**STATE OF HAWAII
DEPARTMENT OF TRANSPORTATION
AIRPORTS**

**ADDENDUM NO. 4
FOR
APRON LIGHT REPLACEMENT
AT
KAHULUI AIRPORT
KAHULUI, MAUI, HAWAII
AND
LANAI AIRPORT
LANAI CITY, LANAI, HAWAII
STATE PROJECT NO. AS1037-12R
AIP PROJECT NO. 3-15-0006-064-2025**

May 27, 2026

DATE :	DWG. NO.
AUGUST 2025	E208
SHEET :	
53 OF 75 SHEETS

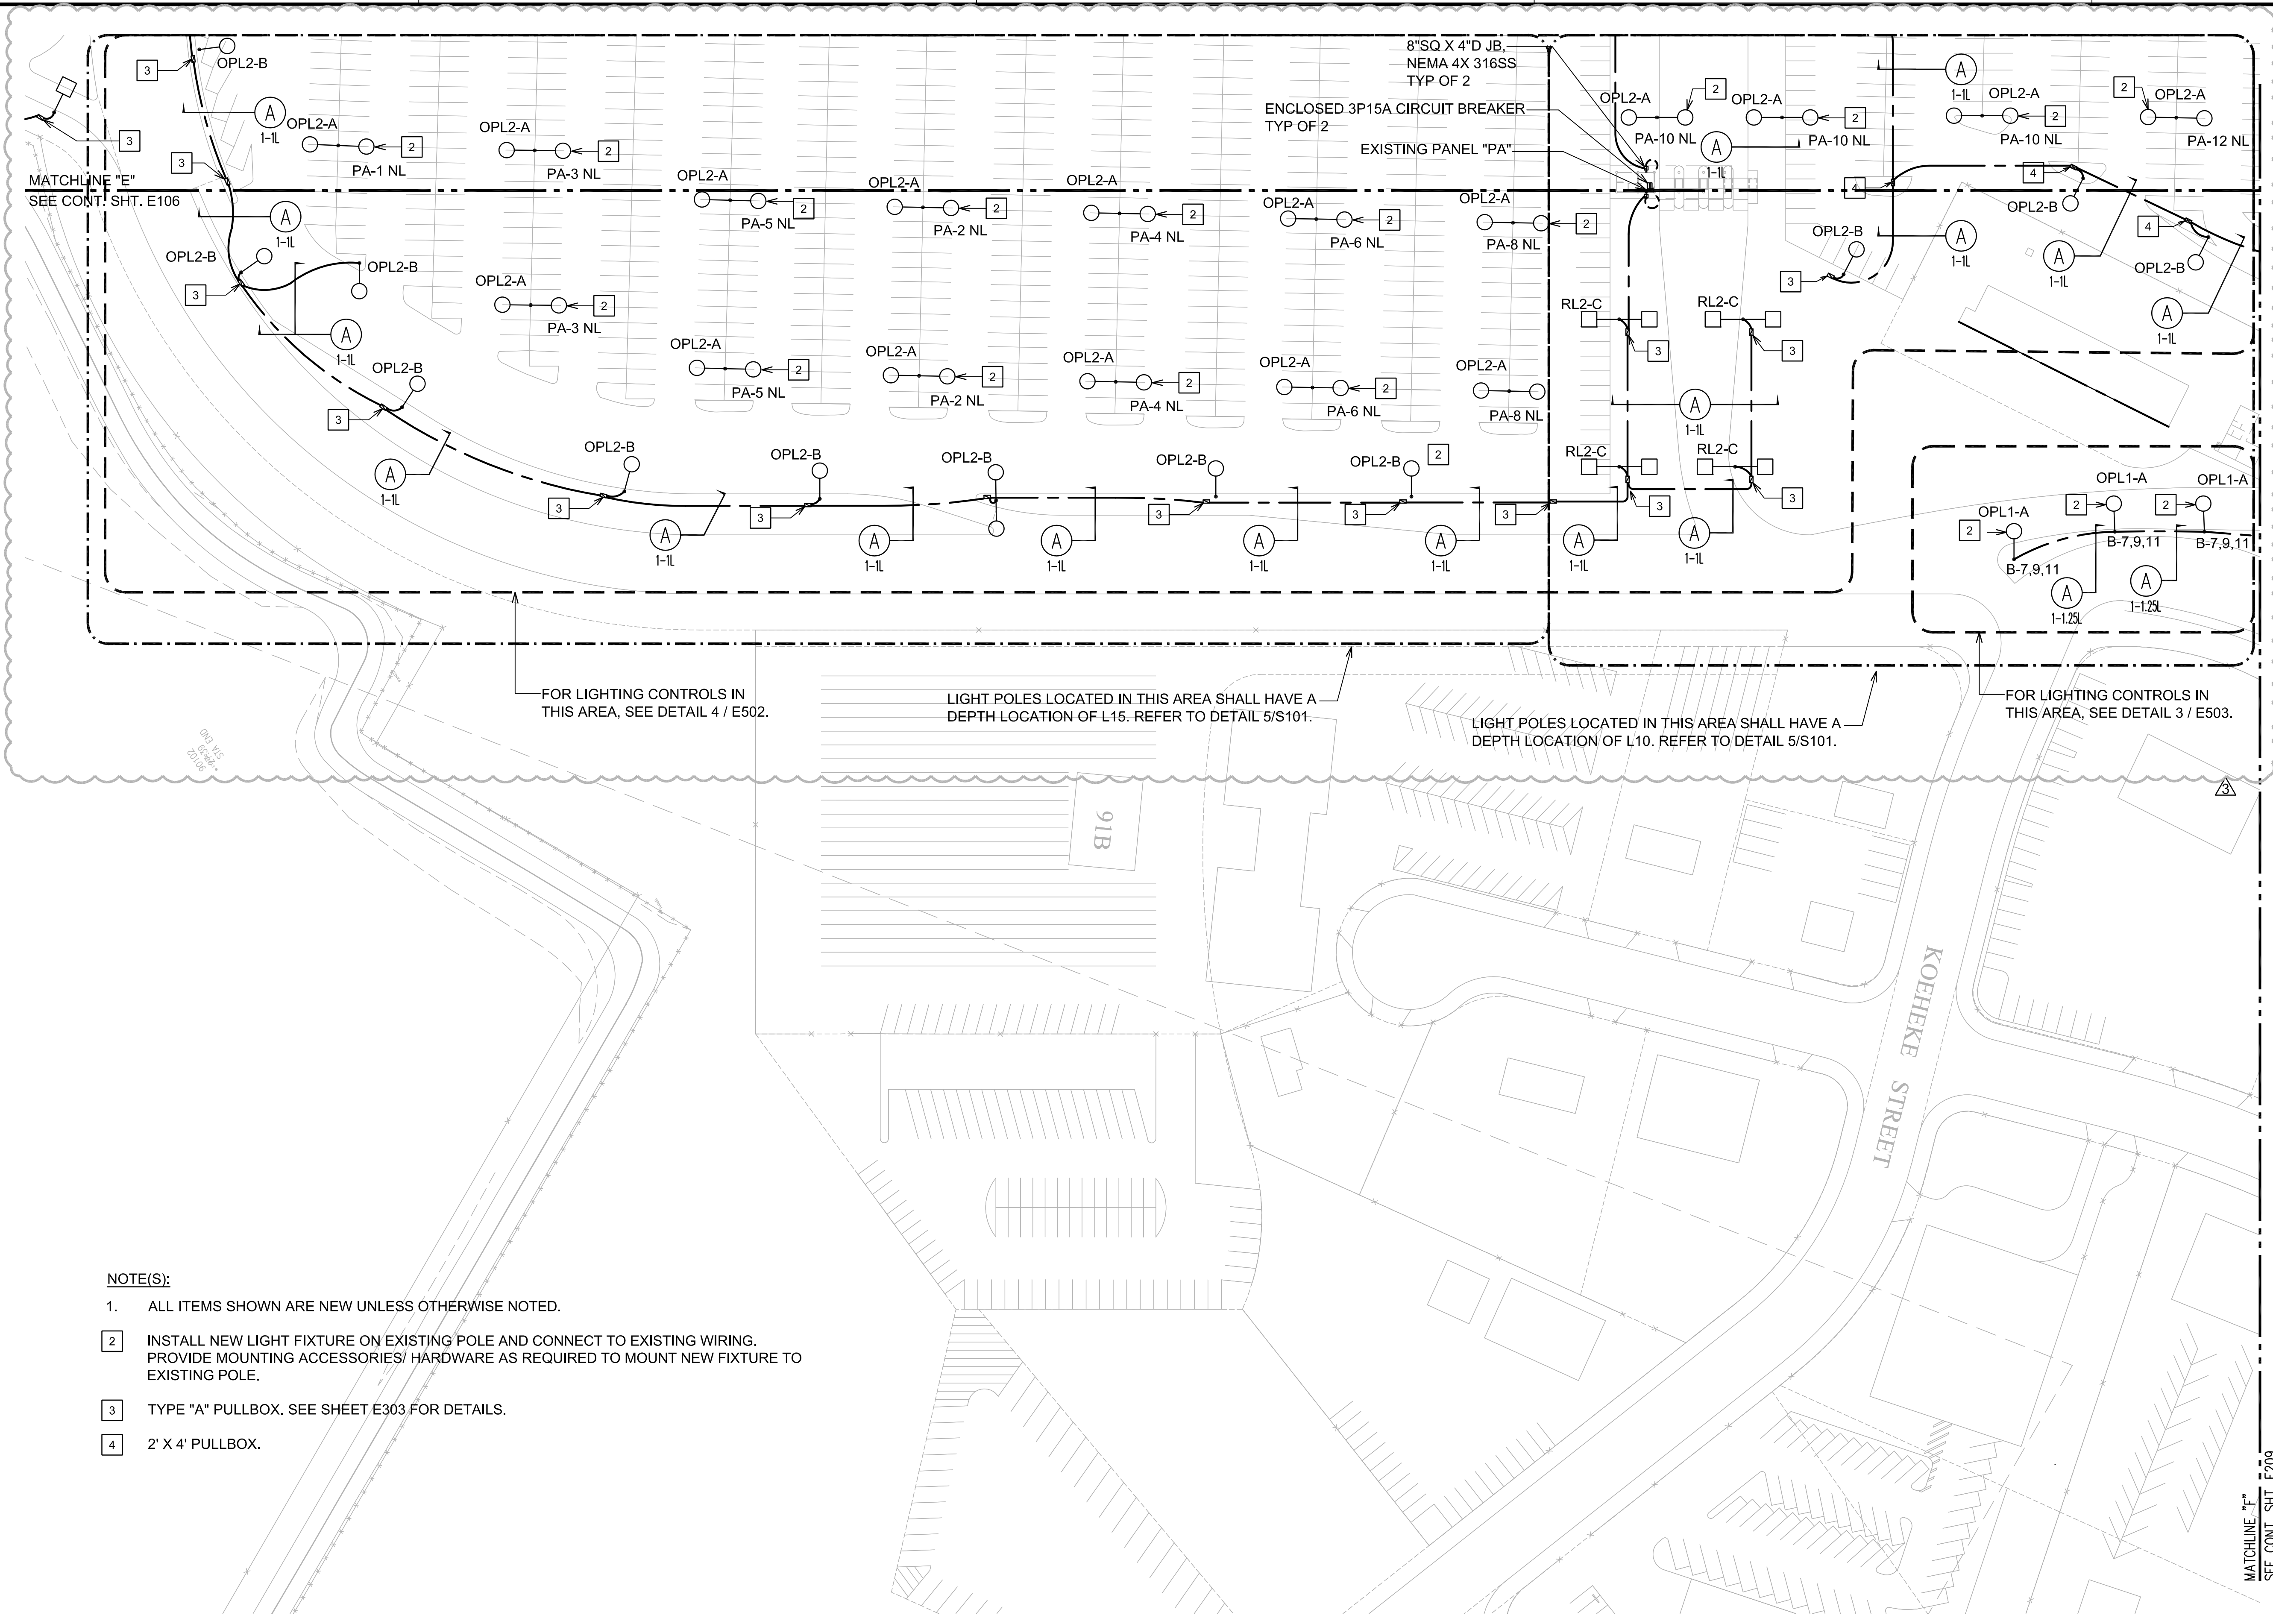
52. ON SHEET E208, NOTE 2, OPL2-A LIGHT POLES. ARE WE REPLACING BOTH FIXTURES ON THESE POLES OR JUST THE NIGHT LIGHT FIXTURE?

Answer: We are placing both of the fixtures on these lights. Revised light fixture schedule accordingly.

E209

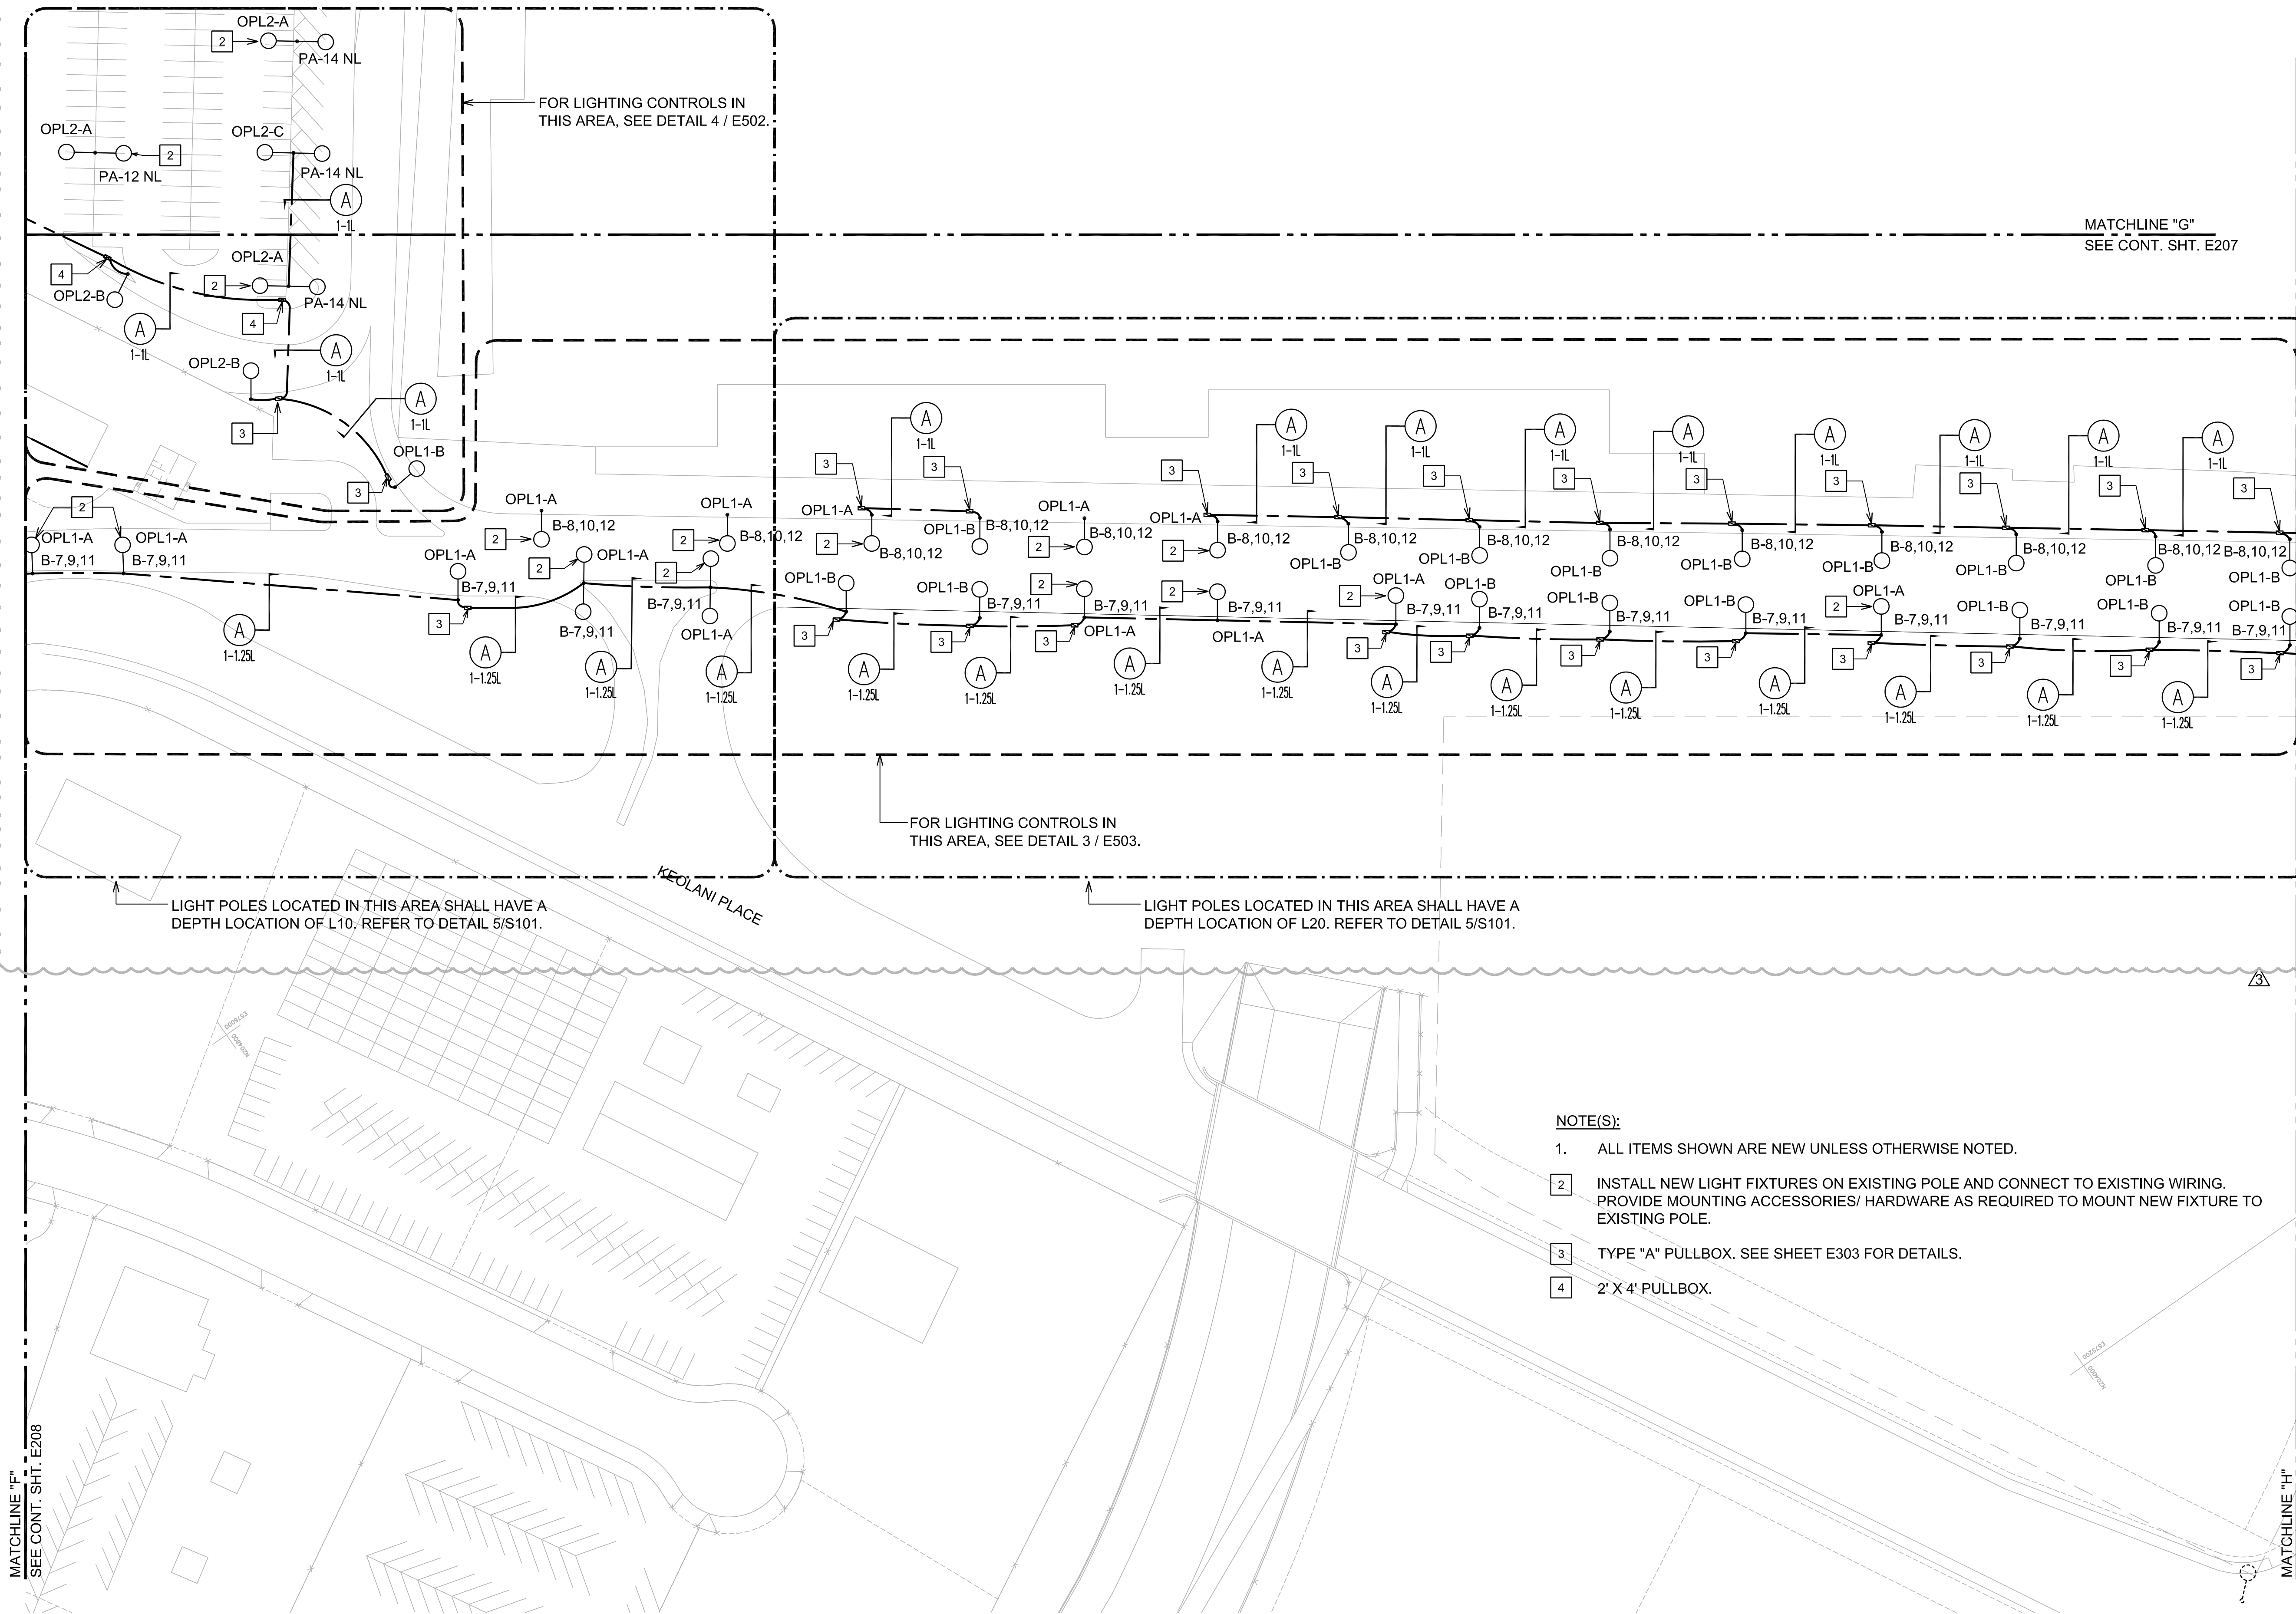
54. ON E209, FOR THE LIGHTING CONTROLS AREA OF DETAIL 4/E502 THERE IS A OPL2-A POLE, PLEASE CONFIRM THIS IS A NEW POLE AND FIXTURE. SEE ATTACHED LINK FOR MARKUP FOR REFERENCE: <https://spaces.hightail.com/space/sTnC4E7aJF>

Answer: It is confirmed that this is a new pole and fixture. Will revise it in the addendum.
